PLANT NAME: Oconee Unit # 1

RE: Oconee Unit 1  
Docket No. 50-269

Please find attached for your review proposed changes to the Oconee Nuclear Station Technical Specifications. The purpose of these revisions is to ensure operation of the Oconee Unit 1, Cycle 2 Core within appropriate fuel design criteria and LOCA limits. Proposed changes are shown in Attachment 1 as replacement pages for the Oconee Nuclear Station Technical Specifications:

PROPOSED TECHNICAL SPECIFICATION REPLACEMENT PAGES

Figure 2.1-1A

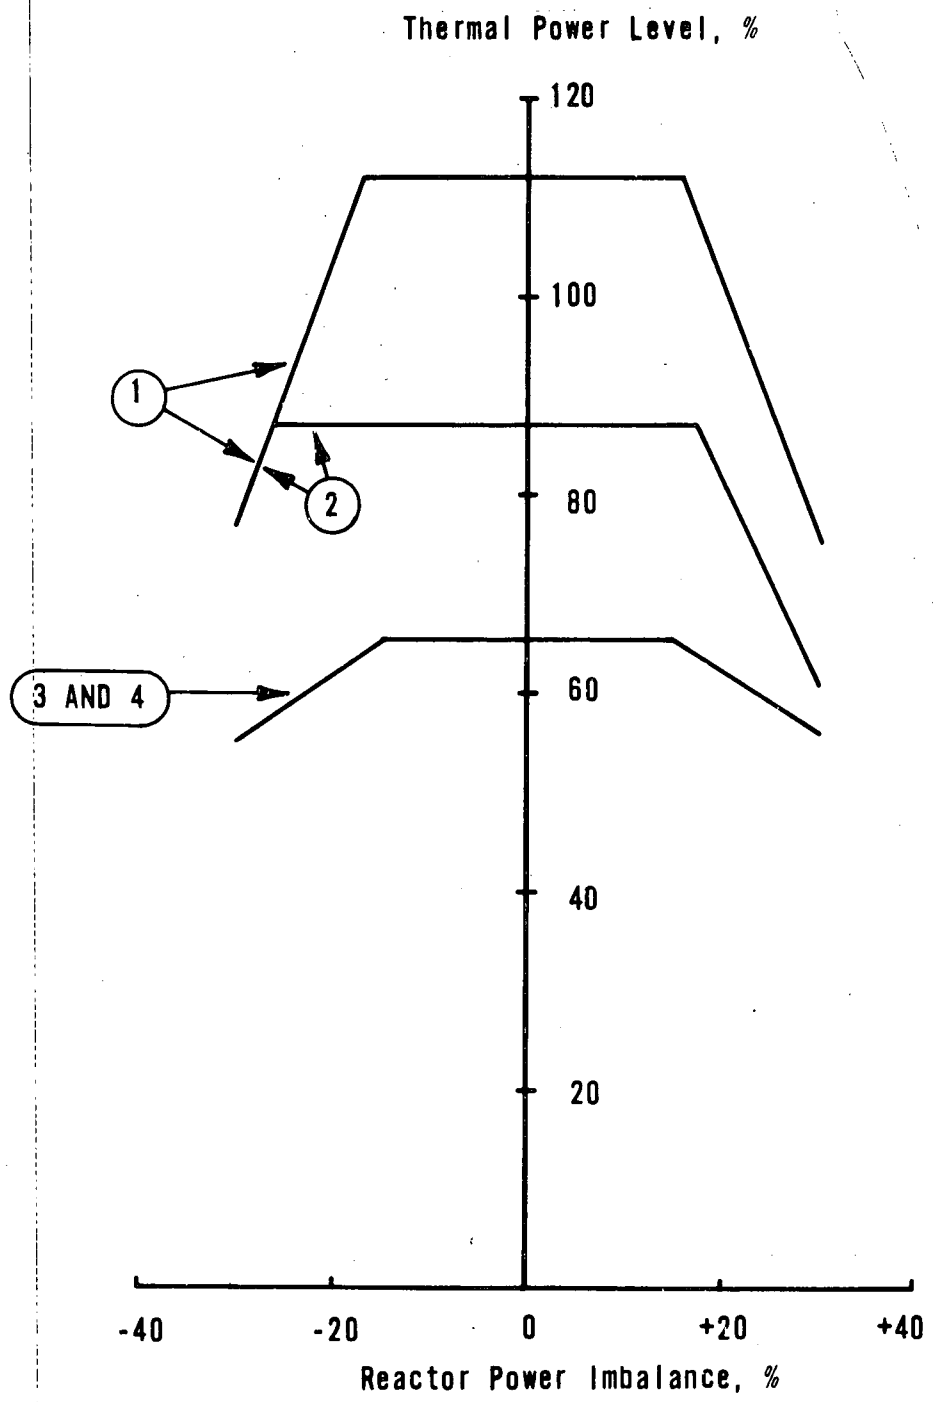
The curve presented in Figure 2.1-1A represents the conditions at which a  
2.1-1B  
2.1-1C

minimum DNBR of 1.3 is predicted for the maximum possible thermal power (112%) when four reactor coolant pumps are operating (minimum reactor coolant flow is  $131.3 \times 10^6$  lbs/hr.) This curve is based on the following nuclear power peaking factors(2) with potential fuel densification effects;

$$F_q^N = 2.67; F_{\Delta H}^N = 1.78; F_z^N = 1.50$$

Figure 2.1-2A

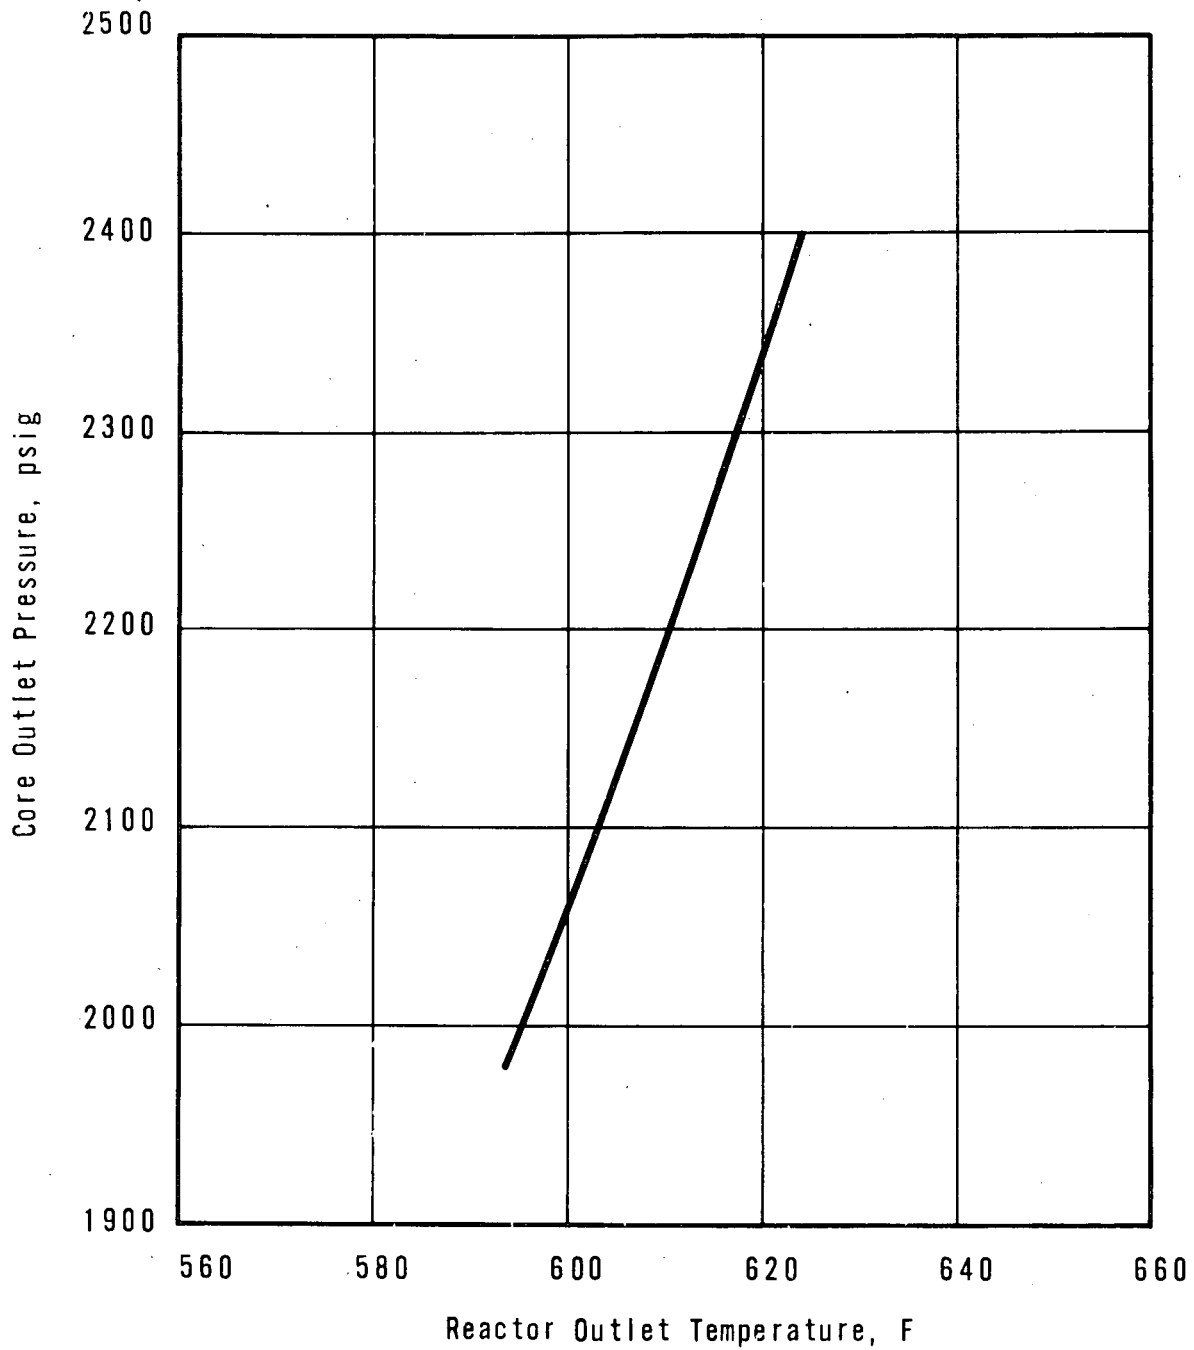
The curves of Figure 2.1-2A are based on the more restrictive of two thermal  
2.1-2B  
2.1-2C

limits and include the effects of potential fuel densification:

1. The 1.3 DNBR limit produced by a nuclear power peaking factor of  $F_q^N = 2.67$  or the combination of the radial peak, axial peak and position of the axial peak that yields no less than a 1.3 DNBR.
2. The combination of radial and axial peak that causes central fuel melting at the hot spot. The limit is  
20.15 kw/ft - Unit 1  
19.8 kw/ft - Unit 2  
19.8 kw/ft - Unit 3

The specified flow rates for Curves 1, 2, 3, and 4 of Figure 2.1-2A correspond  
2.1-2B  
2.1-2C

to the expected minimum flow rates with four pumps, three pumps, one pump in each loop and two pumps in one loop, respectively.

Figure 2.3-2A2

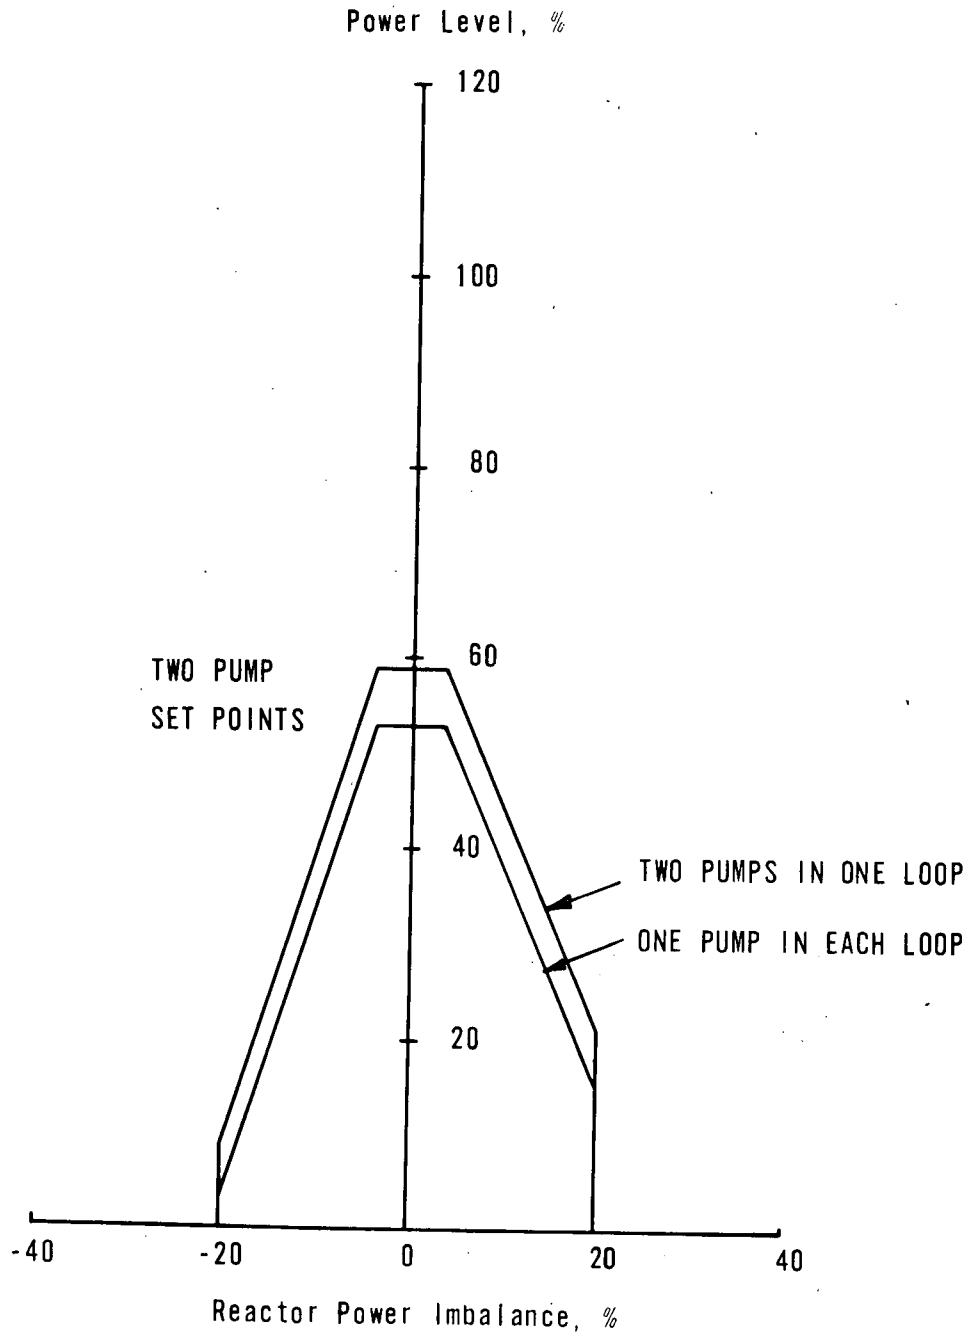
1. Reset the pump contact monitor power level trip setpoint to 55.0%.
2. (Unit 1) Reset the protective system maximum allowable setpoint as shown in Figure 2.3-2A2.

1. Reset the pump contact monitor power level trip setpoint to 55.0%.
2. Trip one of the two protective channels receiving outlet temperature information from sensors in the Idle Loop.
3. (Unit 1) Reset the protective system maximum allowable setpoints as shown in Figure 2.3-2A2. Tripping one of the two protective channels receiving outlet temperature information from the idle loop assures a protective system trip logic of one out of two.

Figure 3.5.2-1A1

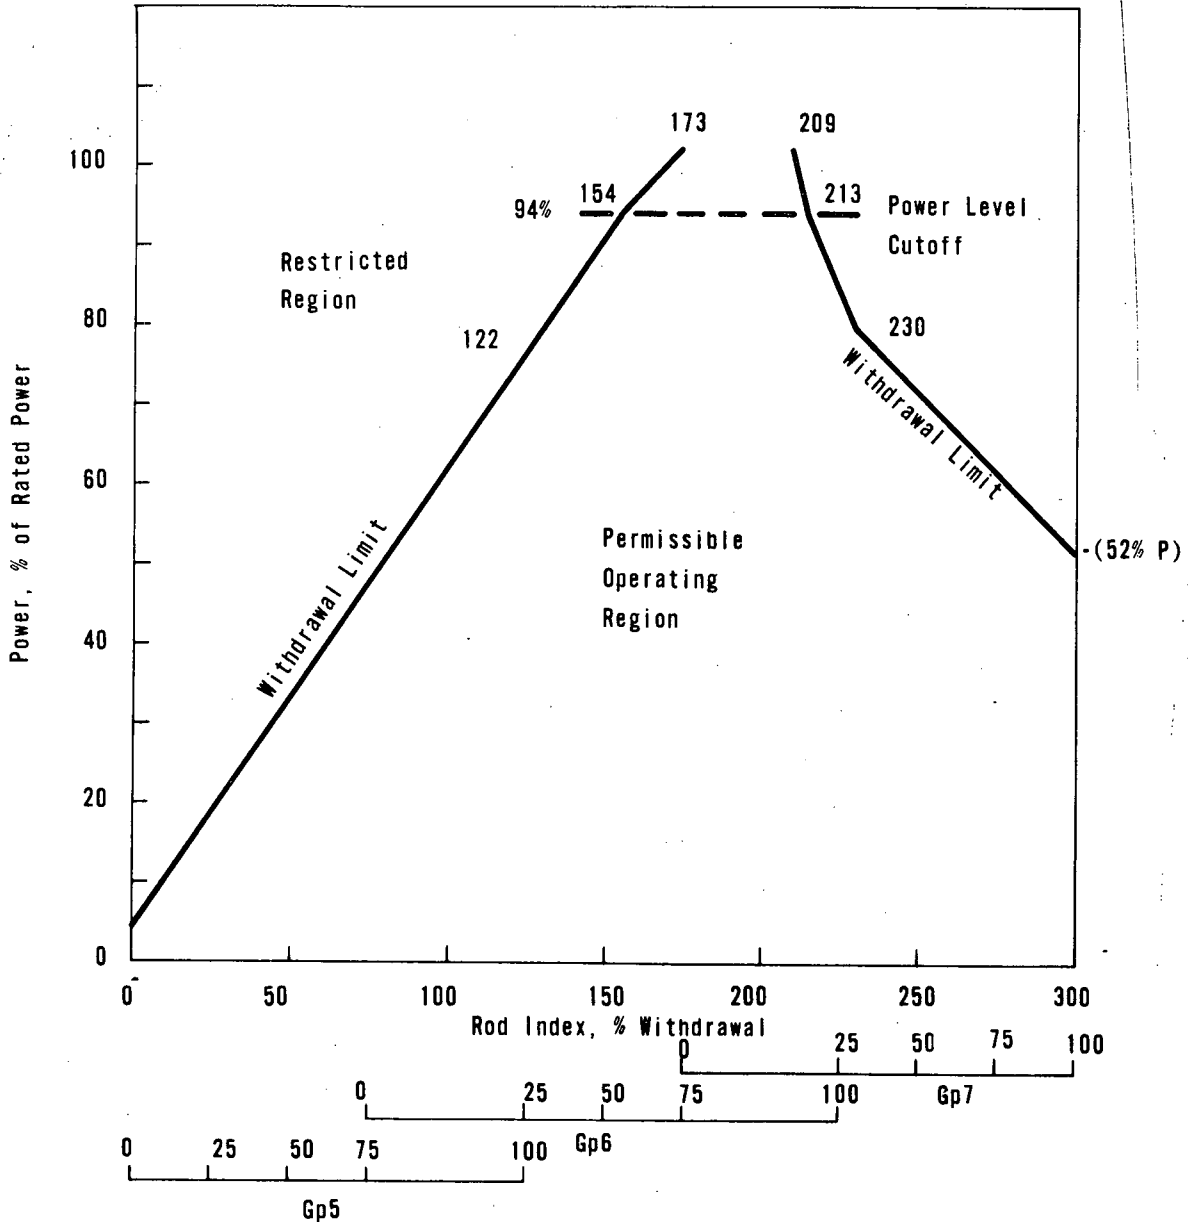
1. Rod index is the percentage sum of the withdrawal of the operating groups.
2. The withdrawal limits are modified after  $250 \pm 5$  full power days of operation.

Figure 3.5.2-3A

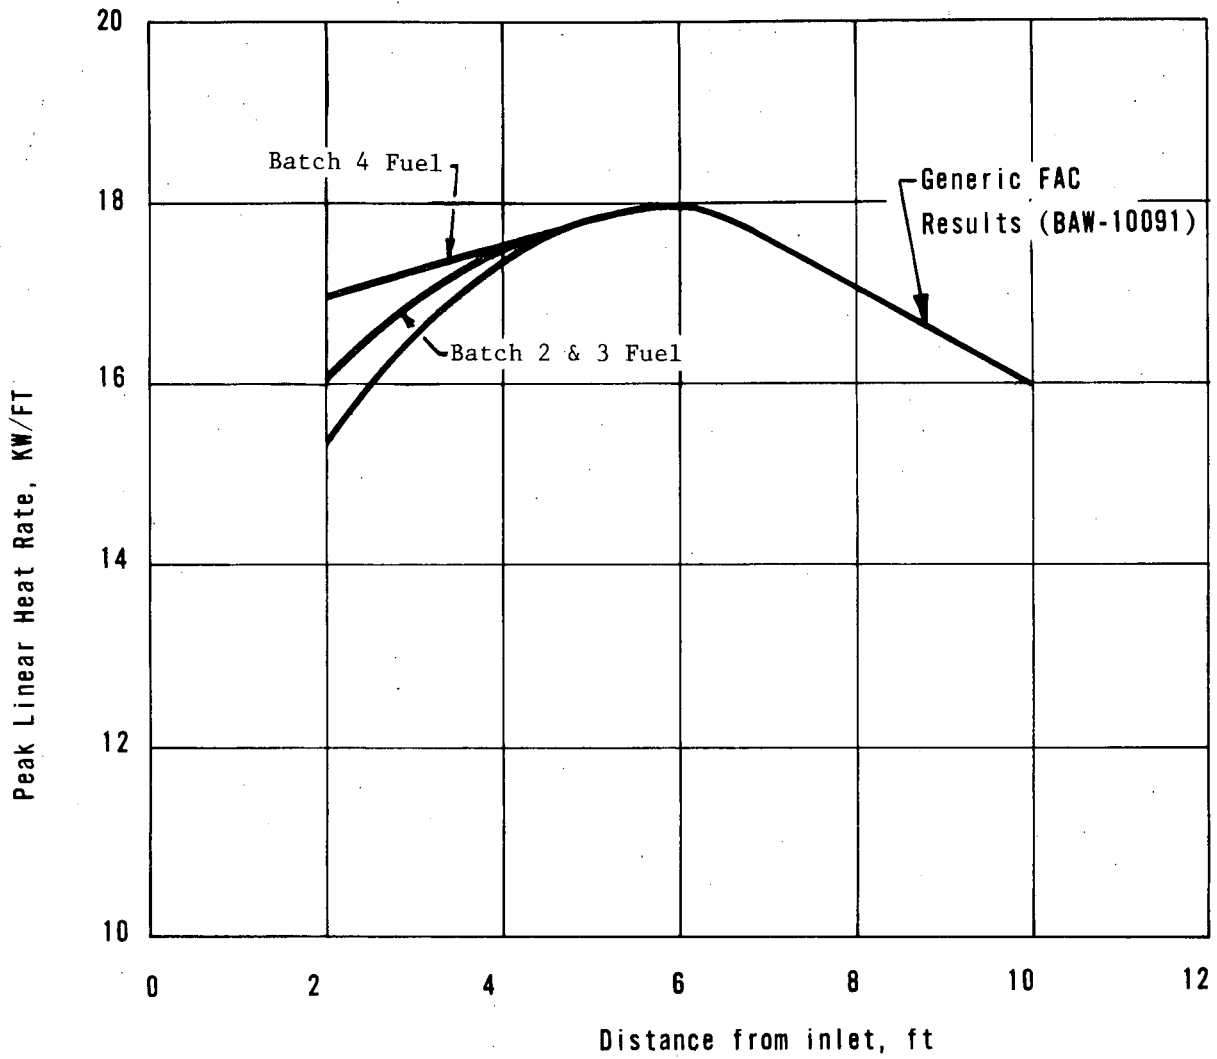
LOCA LIMITED MAXIMUM ALLOWABLE LINEAR HEAT RATE
